Offsite Dose Calculation Manual (ODCM)

UNT-005-014, Revision 6, Change 3

REQUEST/APPROVAL PAGE

LIQUID WASTE MANAGEMENT SYSTEM EFFLUENT SOURCES AND RELEASE PATHWAYS AND POINTS

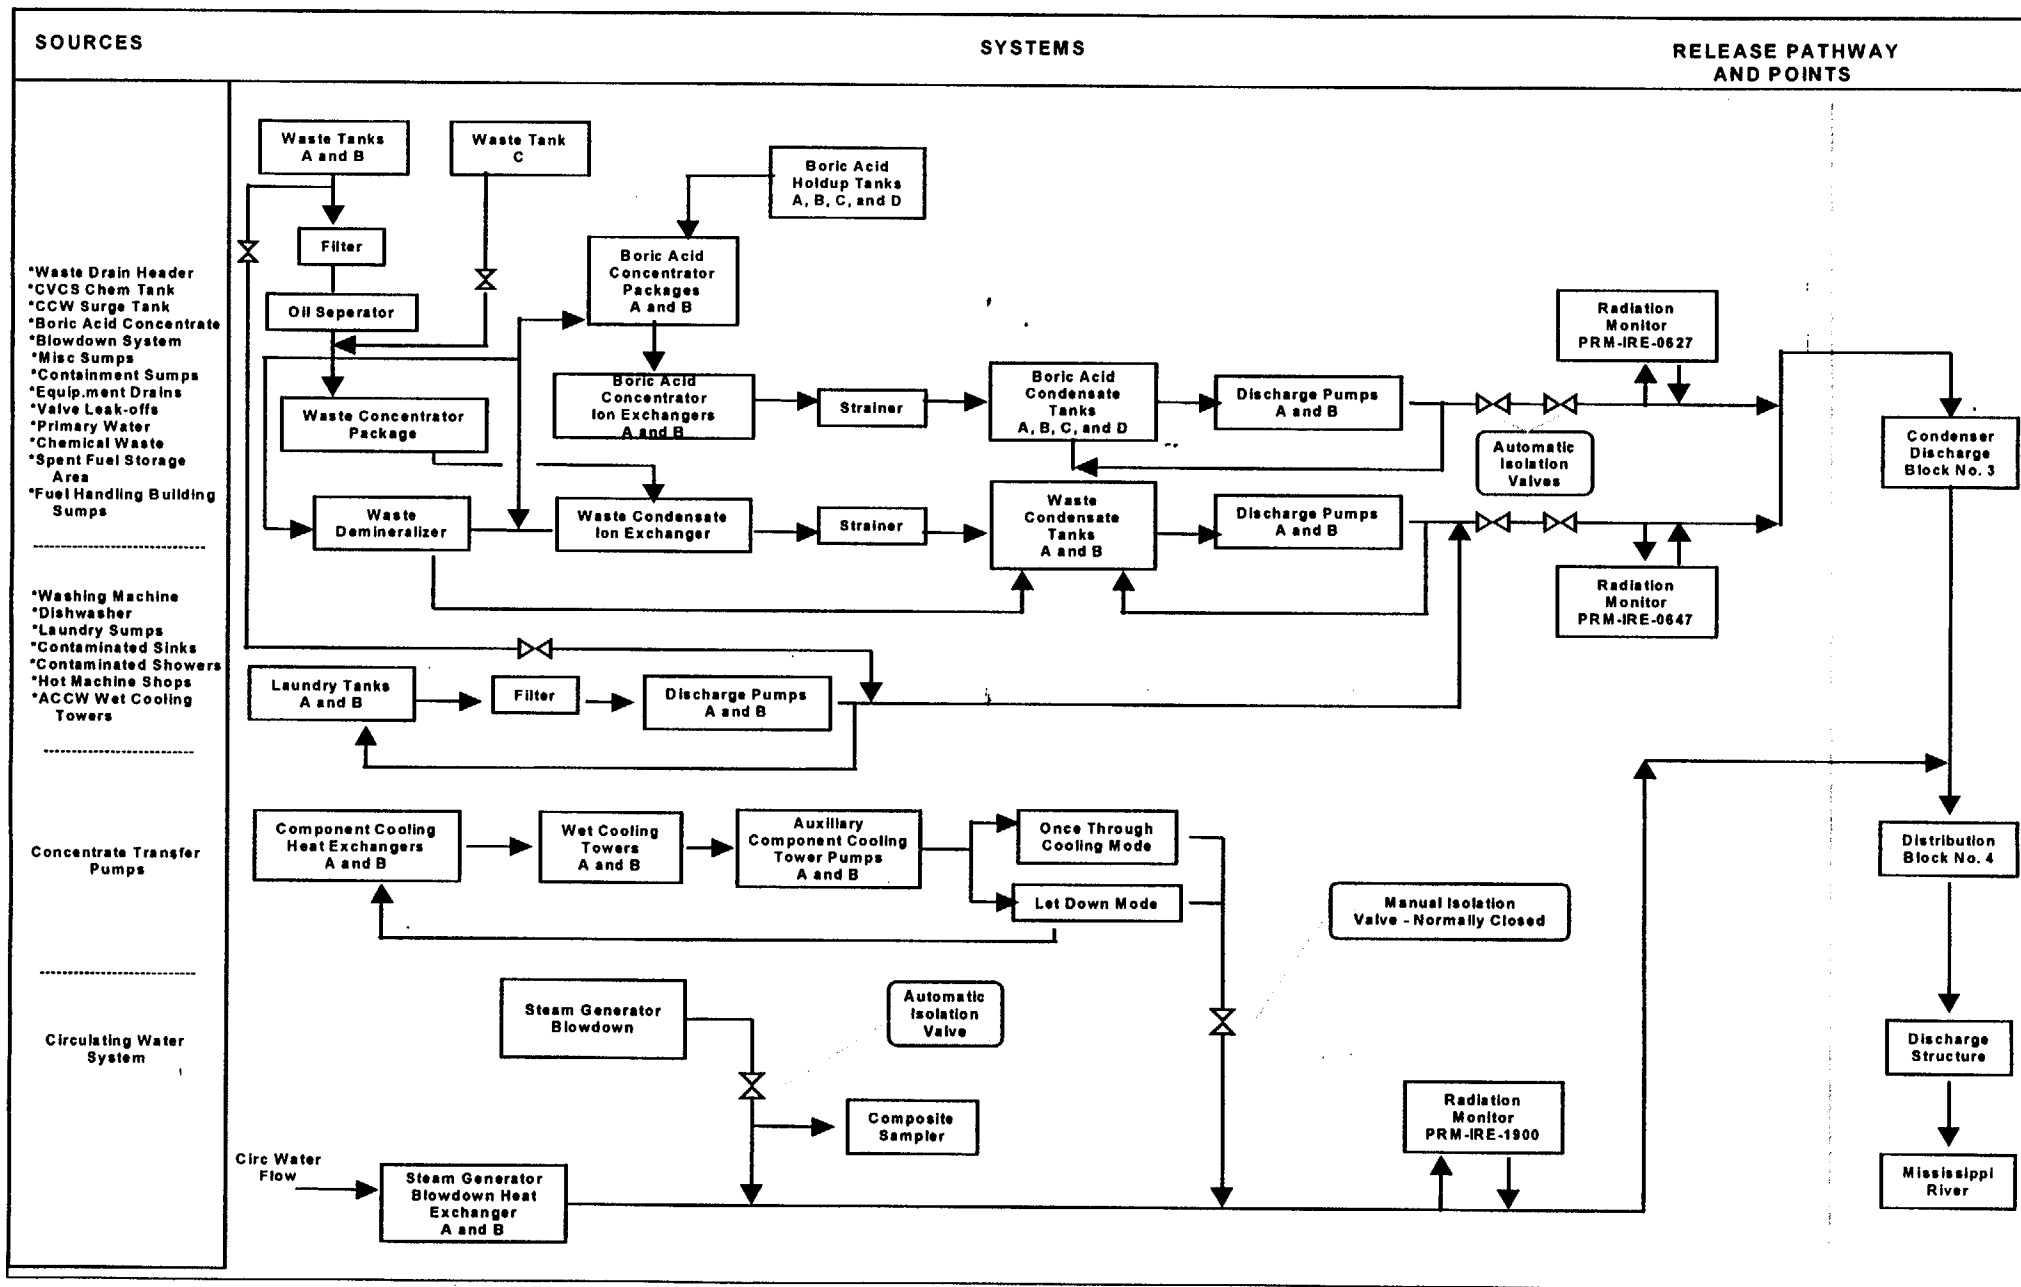
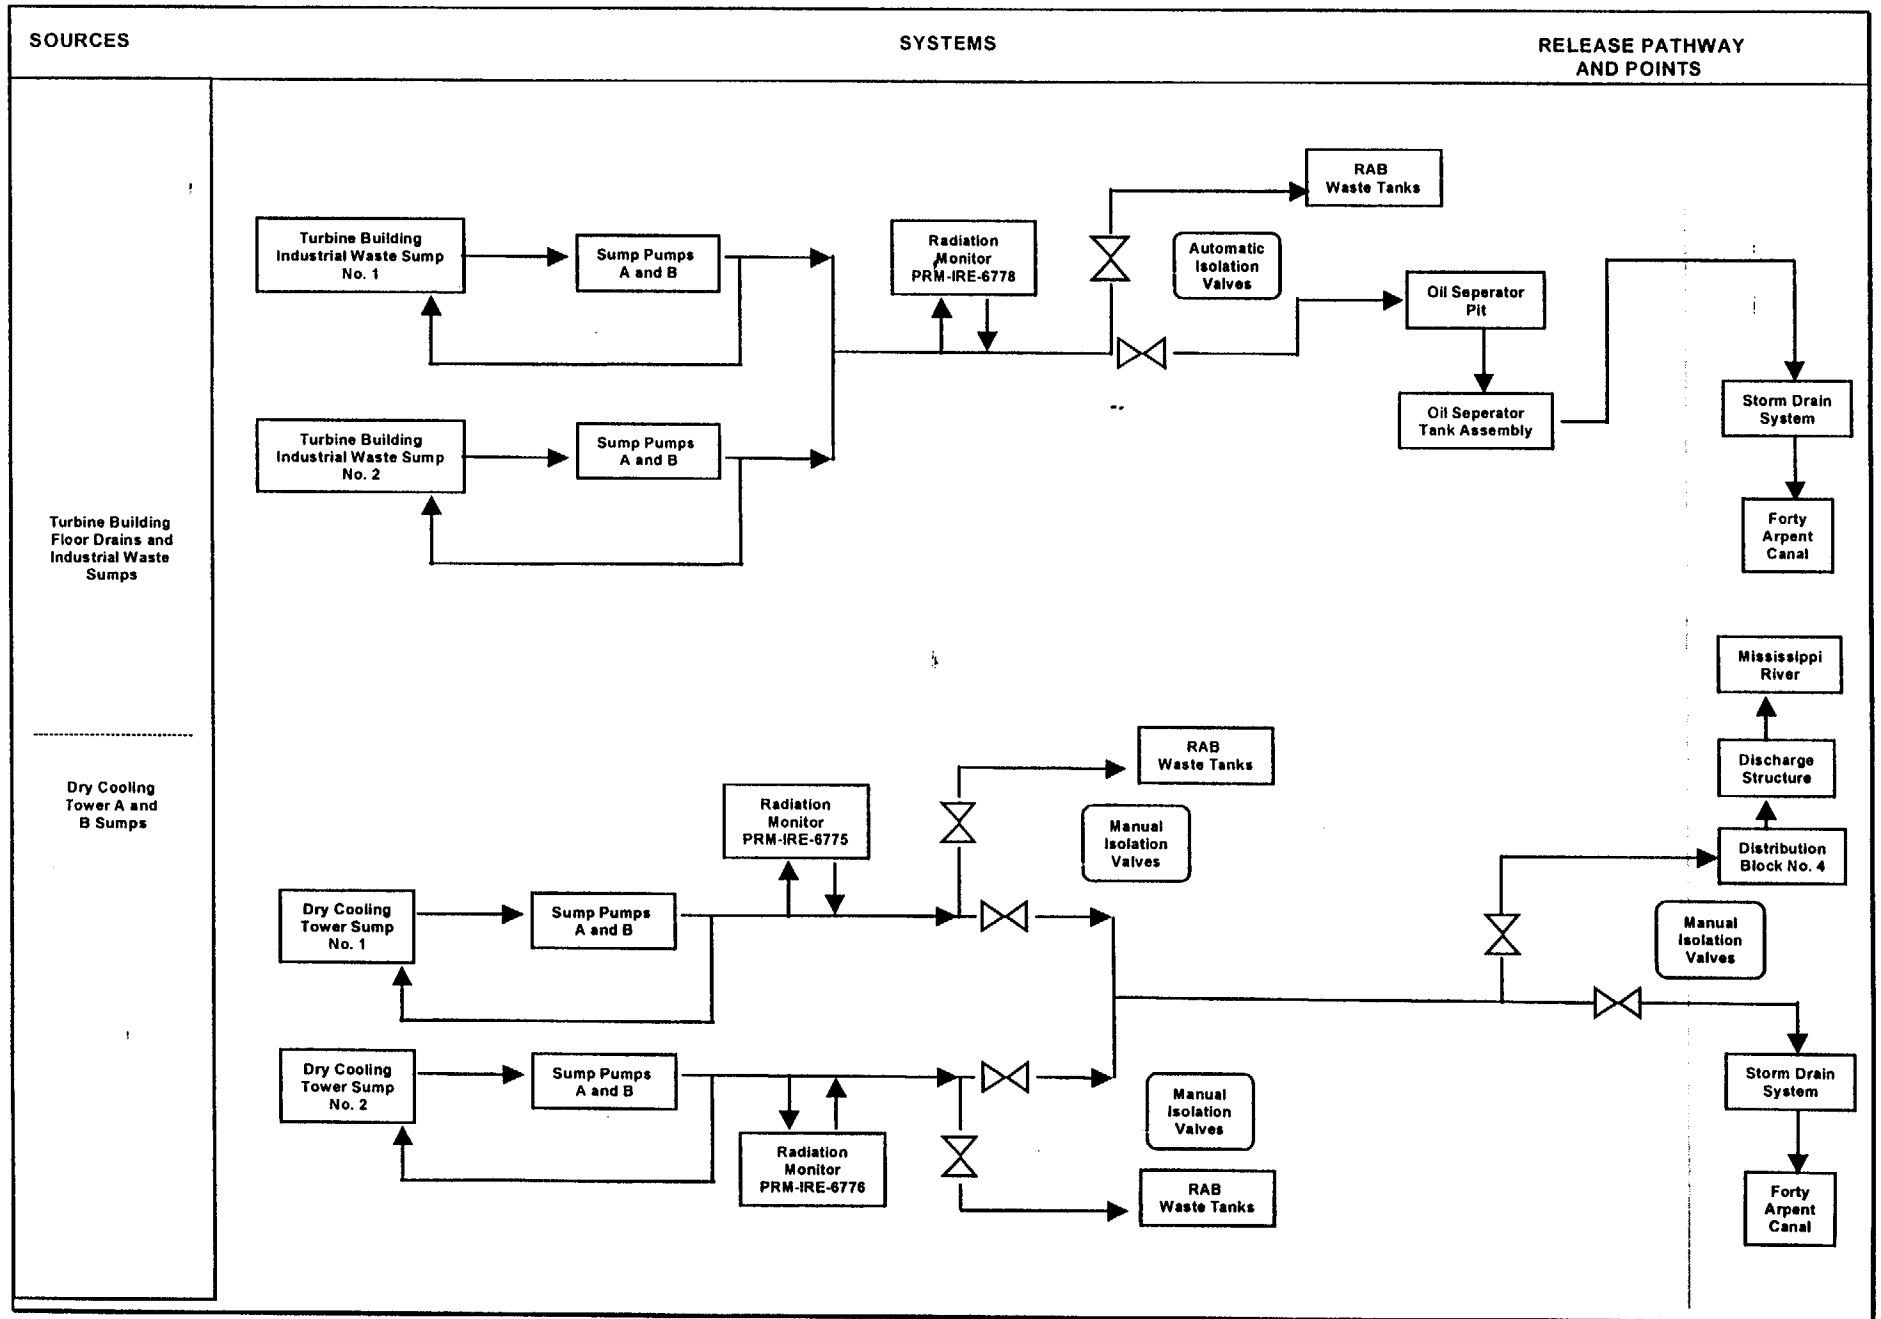
- 1) Added flow path for Dry Cooling Tower Sumps to Circulating Water due to plant design change DC-3521 which allows flow via this path.
- 2) Added a note to the Main Condenser Evacuation System Automatic Isolation valves indicating that the Auto Divert feature of these valves has been disabled due to a plant modification and fixed a typographical on the same attachment (loacl -> local).
(ER-99-3550-00-00)
- 3) Removed milk location MKR-50 due to batch mixing of several sources of milk at the dairy prior to sample collection. Added Christine Herring's dairy as the new control milk location (MKR-40).
